SERVICE BULLETIN 95

SUBJECT: GLASAIR III LANDING GEAR OLEO STRUT WELDED JOINTS

APPLICATION: All Glasair III landing gear oleo struts  
(Serial numbers 051 to 101 in particular)

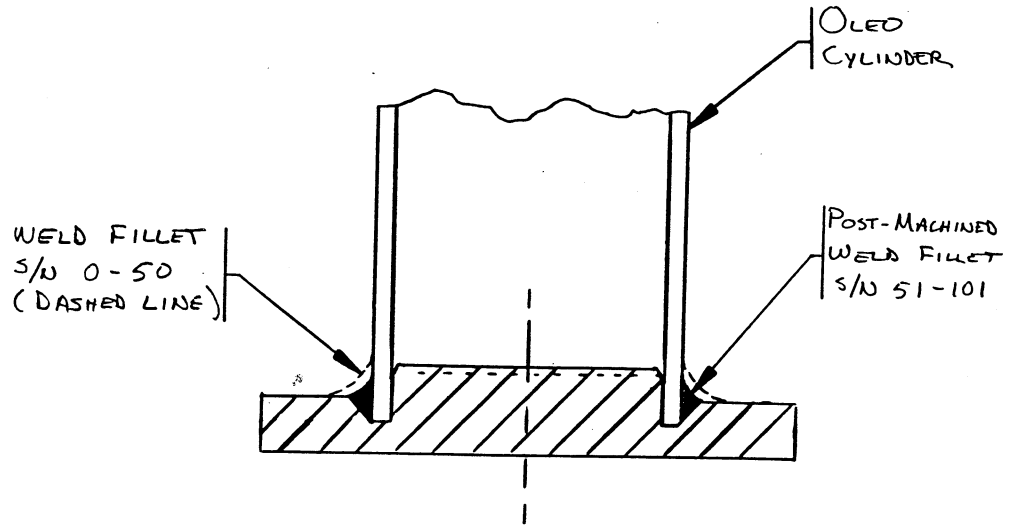
DESCRIPTION: We recently received notification of a failure of the weld at the junction between the chrome oleo cylinder and the fork mounting flange (see illustration). The failure, which occurred on a customer's Glasair III nose gear, resulted in damage to the propeller and required an engine tear-down.

An inspection of the welded joint revealed that the weld had slowly cracked over time as indicated by rust along most of the severed joint and moisture and rust which had invaded the inside of the cylinder. We think that the cracked weld could probably have been spotted with more thorough pre-flight inspection procedures, although engine oil and dirt likely concealed the problem.

FIGURE (1)

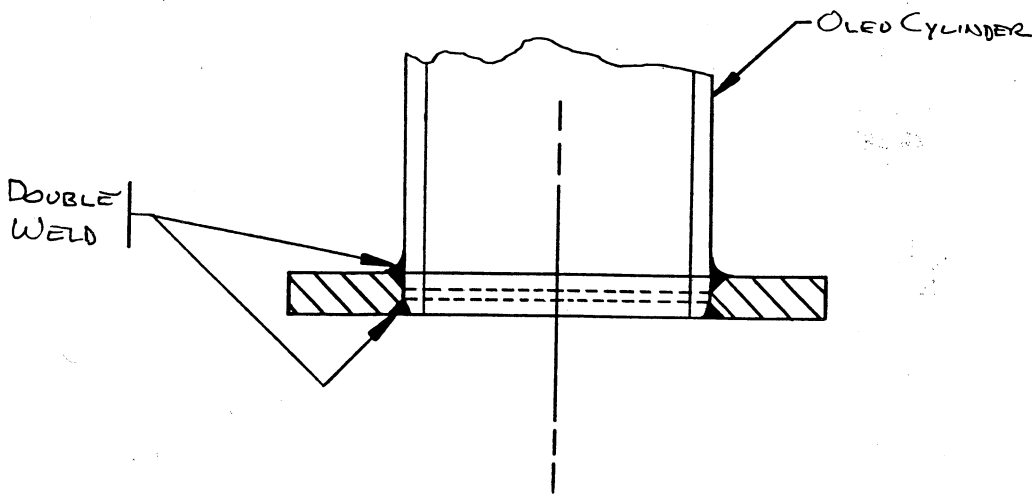
The cylinder that failed came from the second production run of Glasair III landing gear. In this lot, the weld was post-machined to provide clearance for the fork attachment bolts. Possible causes of this failure could be uneven weld penetration compounded by post machining, weld cavities, etc. or an extra hard landing. A hard landing may cause a break or a crack in a weak weld. Subsequent takeoffs and landings could then cause the crack to propagate.

These third production run cylinders have the smaller radius welds to eliminate interference with assembly bolts, but use a different mounting flange design than the first and second production runs. Redesign of the mounting flange allowed a secondary weld to the cylinder on the lower side of the flange and eliminated the deep countersink that invited uneven weld penetration and weld cavities. (Refer to FIGURE [1].)

FORK ATTACH FLANGE  
SERIAL NUMBERS 0 - 101

FORK ATTACH FLANGE  
SERIAL NUMBERS ABOVE 101

It is difficult to predict the extent of the problem or the potential for failure for second production run landing gear. Therefore, we will advise but not require replacement of the chrome oleo cylinders for gear struts with serial numbers 51 to 101. The replacement cost of these components can be considered inexpensive insurance compared to the replacement cost of a propeller, an engine tear-down, or the cost of other components that could be damaged as a result of a gear strut failure.

Since we stock only a few replacement cylinders, we will initiate a special production run of these parts for Glasair III builders who wish to upgrade their oleo struts to the most recent design.
